HISTORIC AND DESIGN REVIEW COMMISSION

May 03, 2017

HDRC CASE NO: 2017-157
ADDRESS: 1017 HAYS ST
LEGAL DESCRIPTION: NCB 1655 BLK C LOT 16
ZONING: R-5
CITY COUNCIL DIST.: 2
DISTRICT: Dignowity Hill Historic District
APPLICANT: Jerry Woolf/JB Woolf Shed and Garages
OWNER: Juan Perez
TYPE OF WORK: Construction of a rear accessory structure, demolition of existing structure
REQUEST:

The applicant is requesting a Certificate of Appropriateness for approval to construct a rear accessory structure at 1017 Hays.

1912 SANBORN MAP

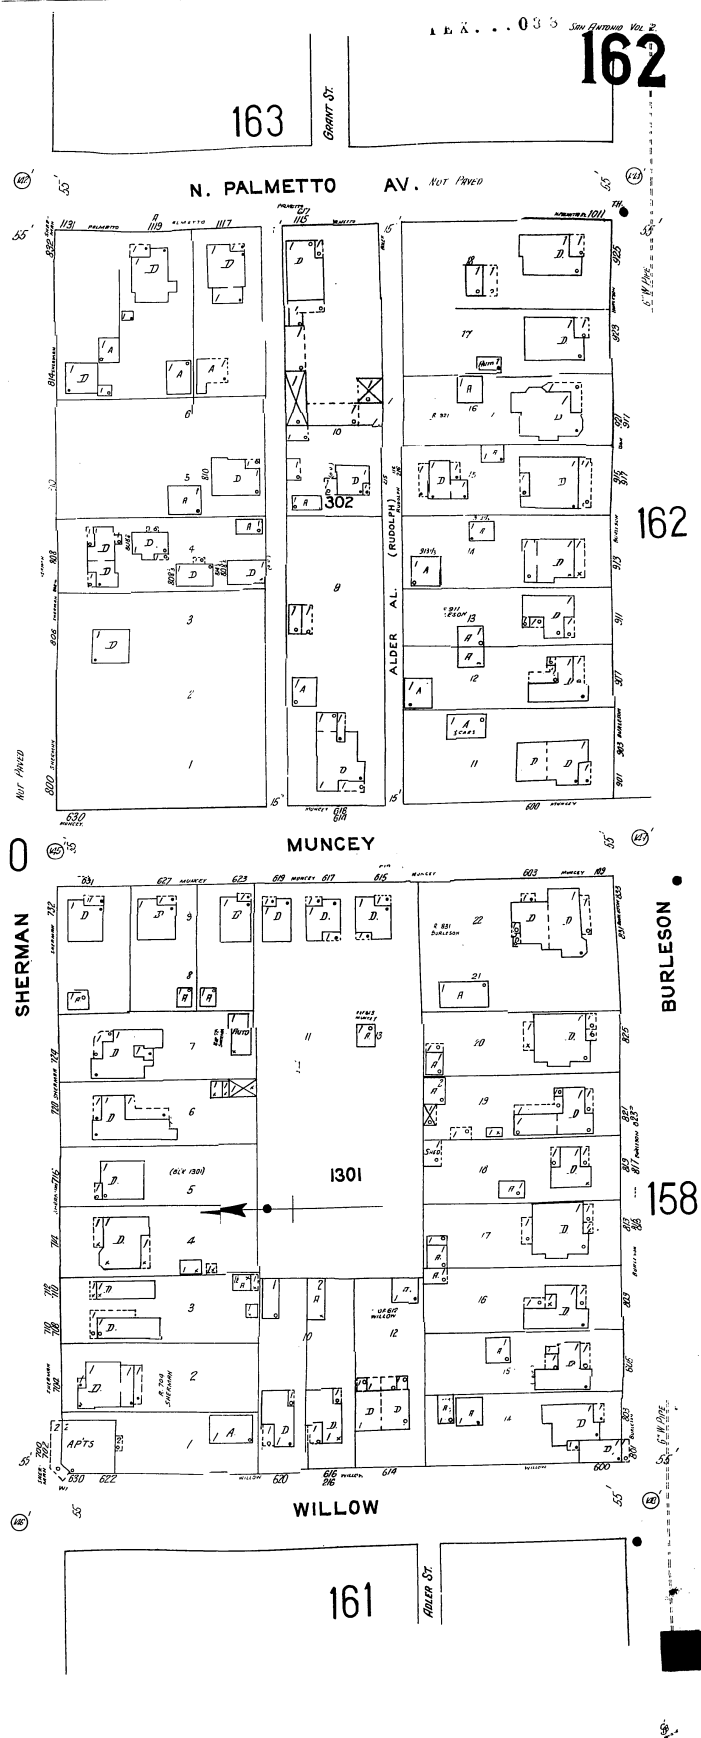
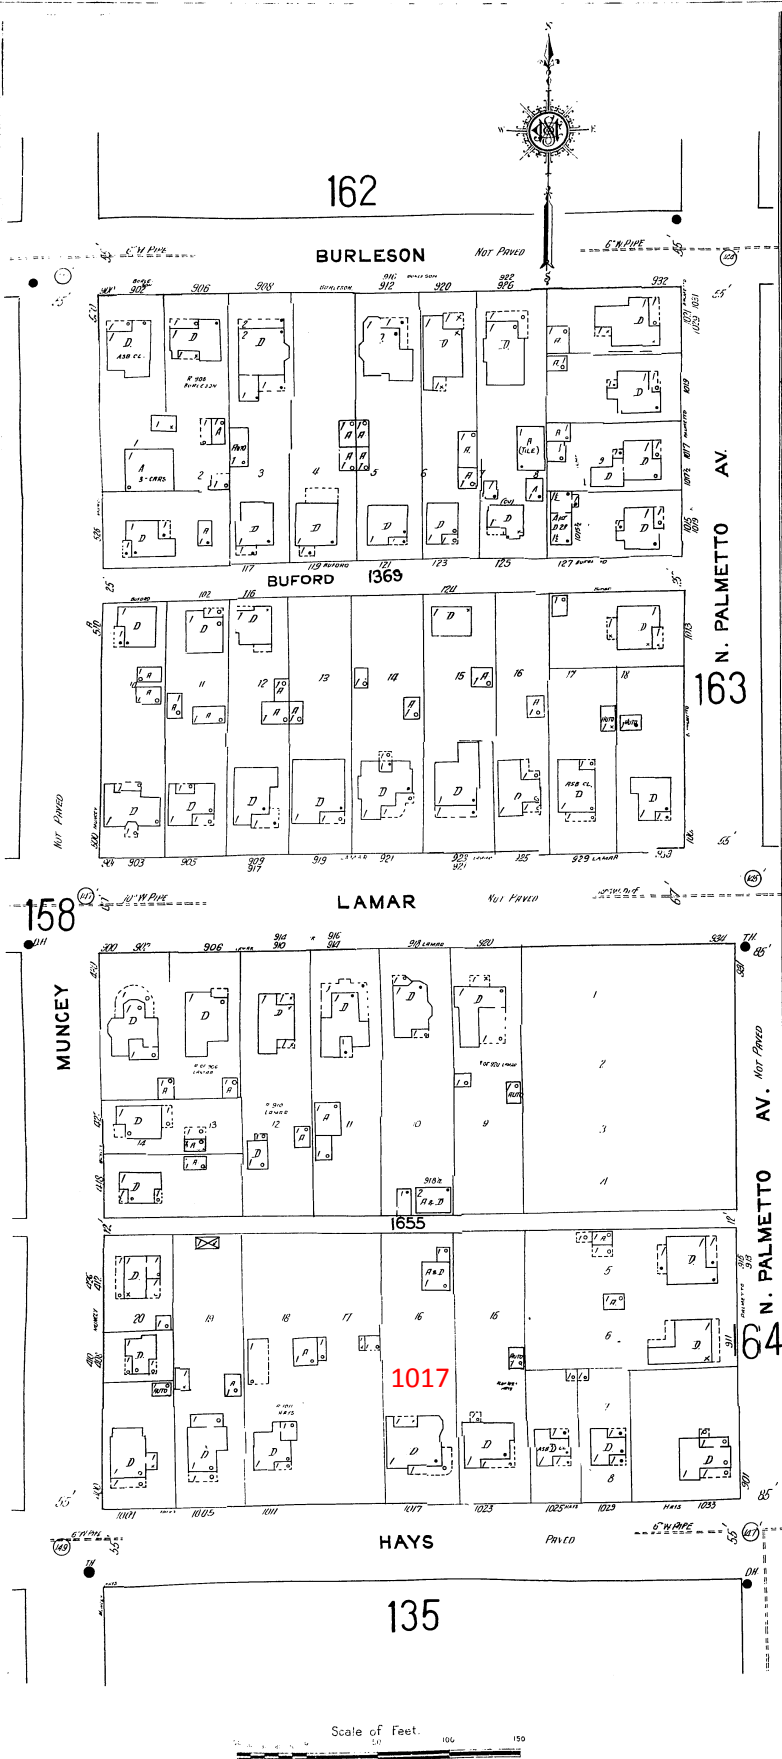
- b. **DEMOLITION** – The rear of the property previously featured two accessory structures. One structure appears on the 1951 Sanborn map; however, this structure features a footprint that is inconsistent with the previously removed structure. OHP has not processed a demolition application for this structure. These structures are located in the location typical for accessory structures that are original to the property and or contributing to the district. The applicant has noted that the existing structure collapsed in April of 2016. OHP finds the removal of the accessory structure to be eligible for Administrative Approval based on comparisons of the historic Sanborn maps and photos provided by the applicant.

PLOT PLAN
FOR BUILDING PERMITS

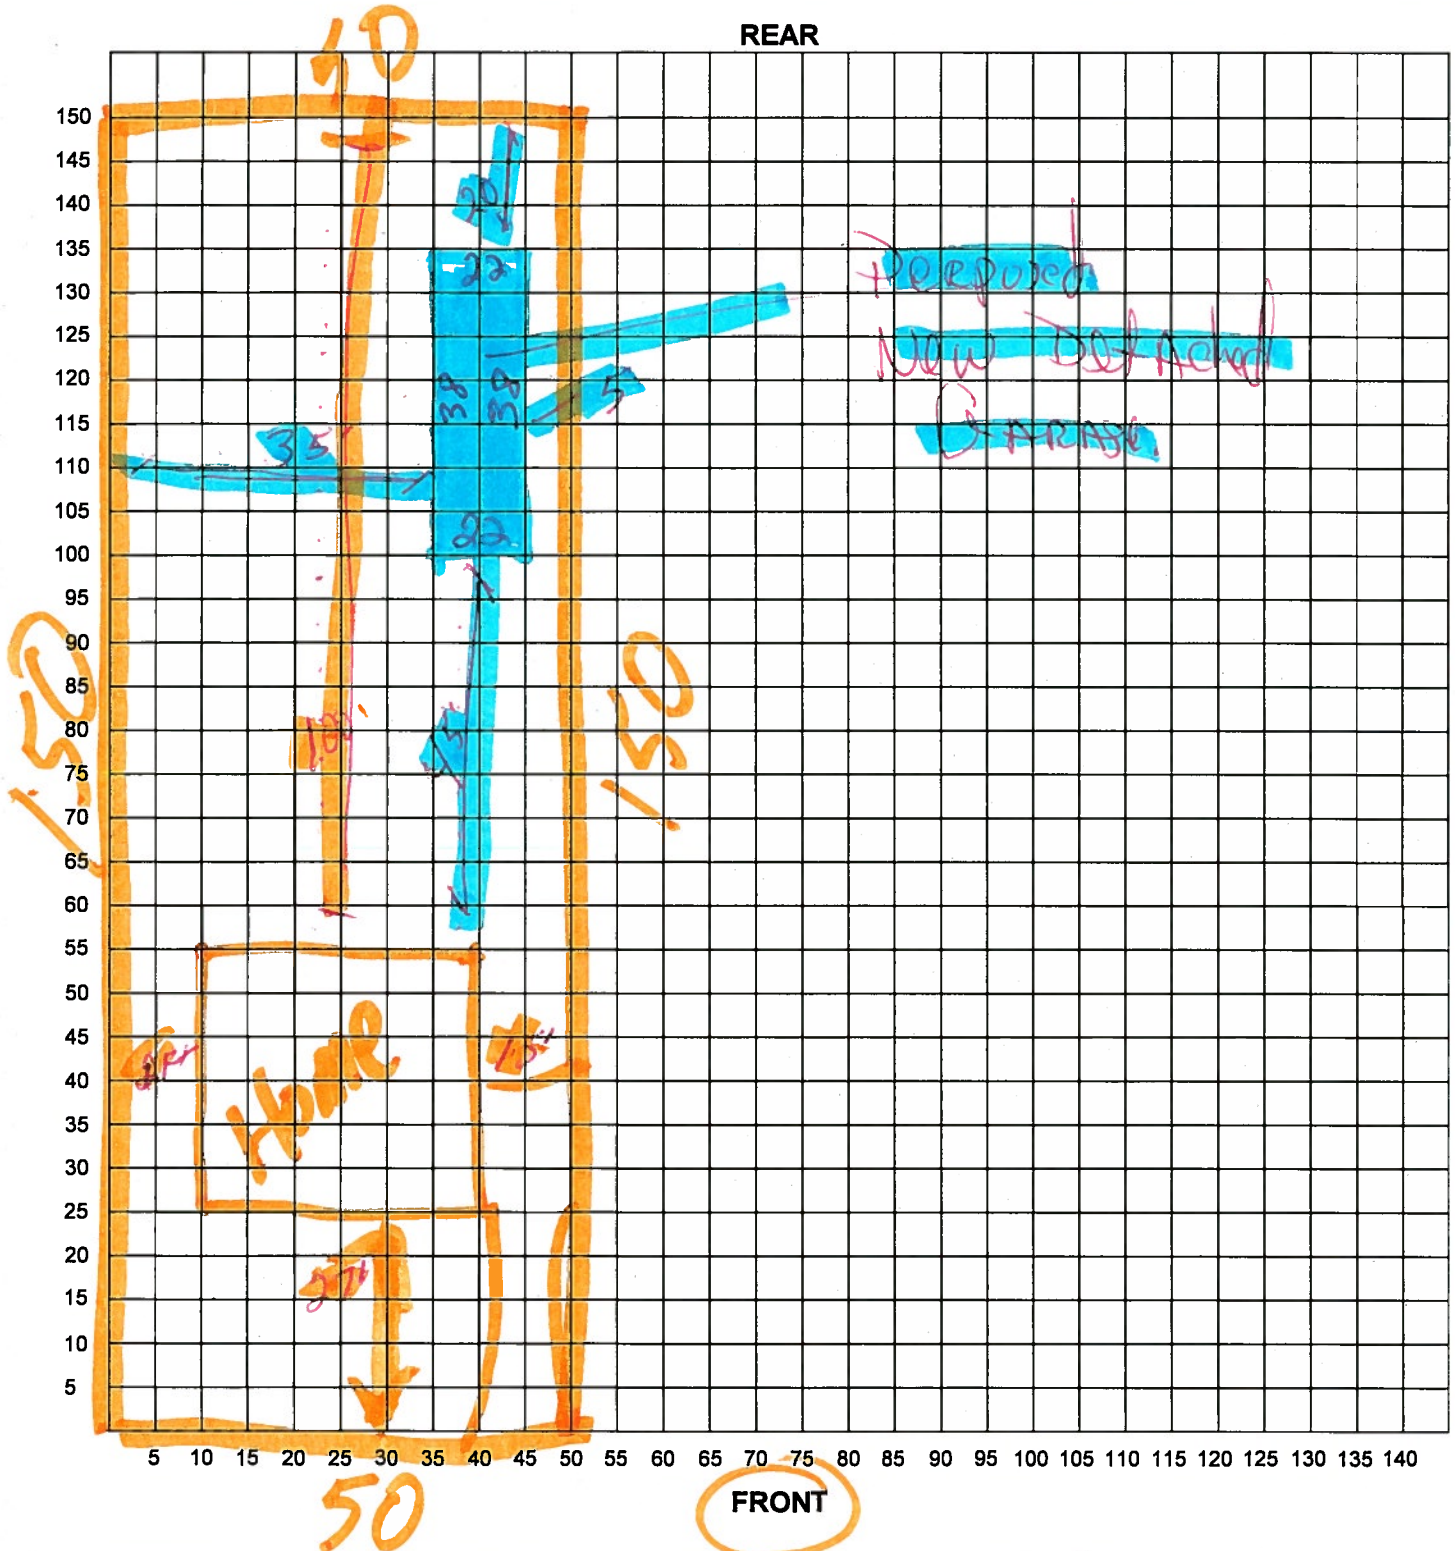
- f. **SETBACKS & ORIENTATION** – The applicant has proposed to locate the accessory structure in the northeast corner of the lot. Typically, historic accessory structures are found at the rear of lots, often in a rear corner. The applicant has noted setbacks of five feet from the property line. This is consistent with the Guidelines.

FRONT VIEW
22 WIDE
38 DEEP

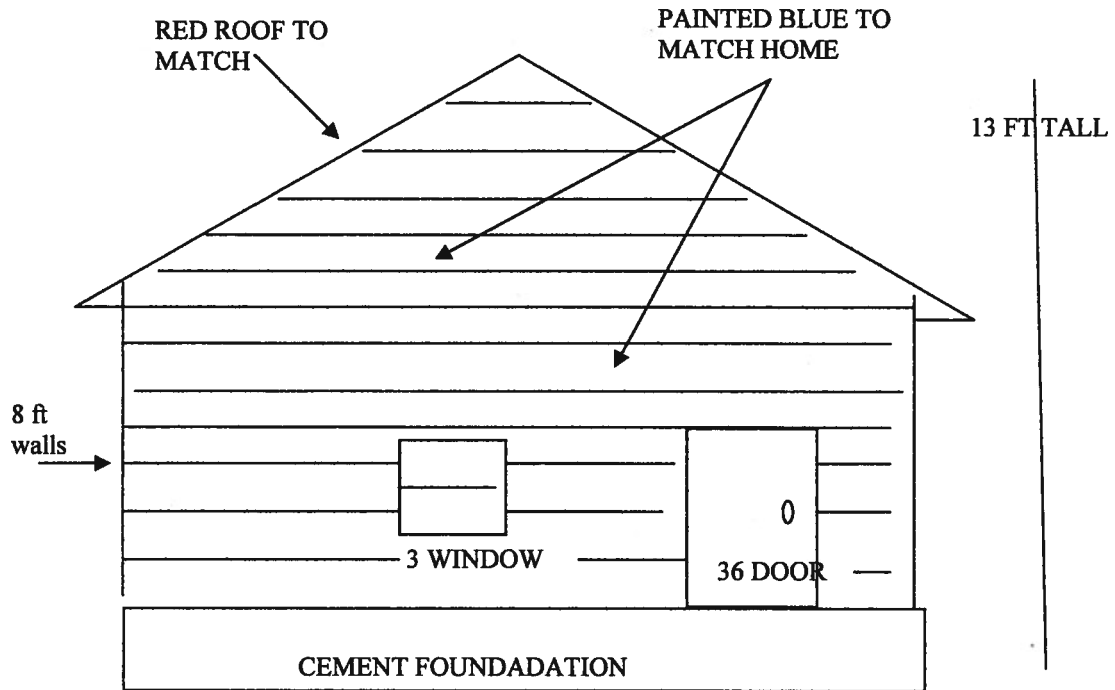
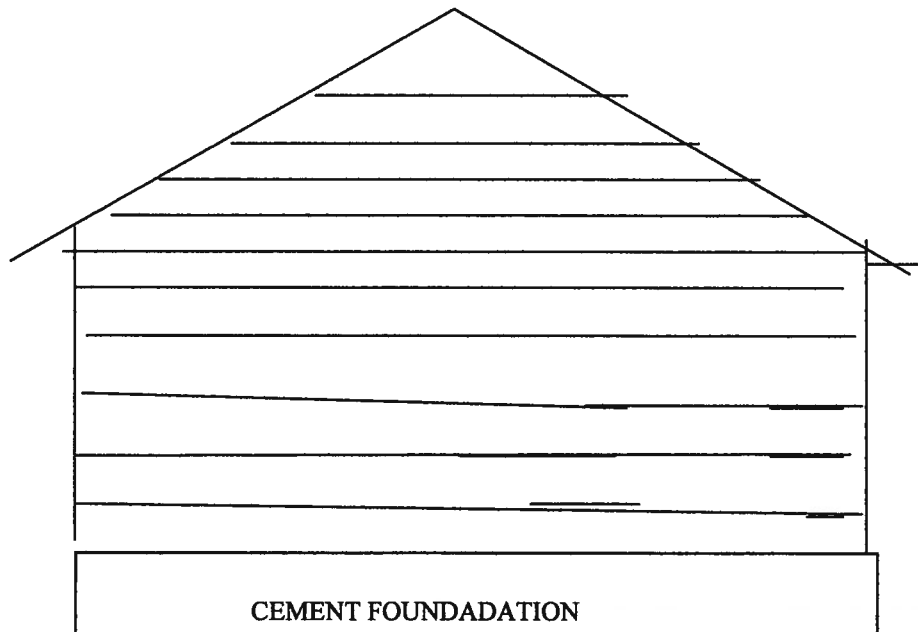
- c. **MASSING, FORM & BUILDING SIZE** – The applicant has proposed for the accessory structure to feature an overall footprint of twenty-two (22) feet in width and thirty-eight (38) feet in length. The proposed footprint of 836 square feet is more than fifty percent of that of the primary historic structure, which was constructed in 1910

and features a footprint of approximately 1,300 square feet. The Guidelines for New Construction 5.A.ii. notes that new accessory structures should be no larger in plan than forty (40) percent of the primary historic structure's footprint. The proposed footprint is not consistent with the Guidelines.

- d. **WINDOWS & DOORS** – The Guidelines for New Construction 5.A.iv. states that window and door openings should be similar to those found on historic accessory structure in the district or those on the primary historic structure in terms of their spacing and proportions. The applicant has proposed one front window and one door opening and has noted these are to match those of the primary historic structure. Staff finds that a window and door that feature historic profiles should be installed and that details of both should be submitted to staff for approval prior to installation.

- i. That the proposed accessory structure is reduced in square footage to be no larger than forty (40) percent of the primary historic structure's footprint.
- ii. That the applicant install windows and doors that match those of the primary historic structure in terms of materials and profiles.
- iii. That the applicant install cement lap siding that features a smooth finish and an exposure of four (4) inches.
